PRODUCT CAMPAIGN BULLETIN

APPLICABILITY: 2015-18MY Forester **NUMBER:** WUM-98R
SUBJECT: Occupant Detection Wiring Harness Inspection **NHTSA ID:** 19V-701
DATE: 10/14/19
REVISED: 10/28/19

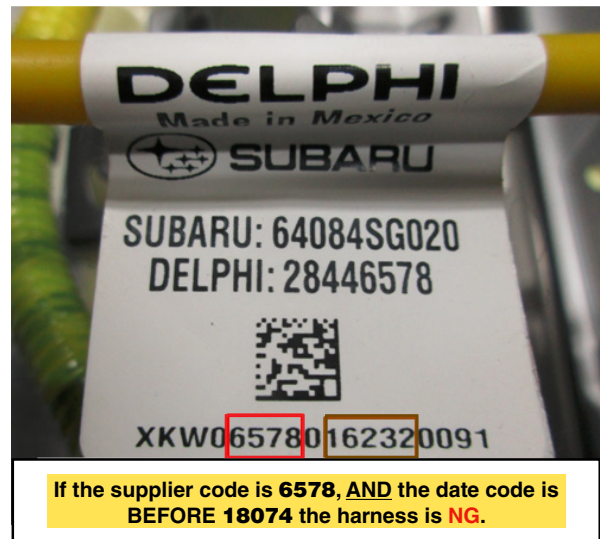
Step 1. If the date code (**BROWN** box in photo) on the label is **AFTER 18074**, the harness is **OK**. See additional ****NOTE** below.

Step 2. If the date code is **18074** or **BEFORE AND** has the supplier code **6578** (**RED** box in photo) on it, the harness is **NG** and the seat cushion assembly must be replaced. Always order the most up-to-date part number seat cushion assembly for the VIN being repaired. Follow the Service Procedure in the applicable Service Manual for the repair.

- “16” is the year (2016) and “232” is the 232nd day of the year: “16232”.

IMPORTANT: The Repair Order must include the Original **AND** (if the seat bottom assembly was replaced) the replacement part's supplier code and date information as outlined above. Use the following example: **6578-18074**.
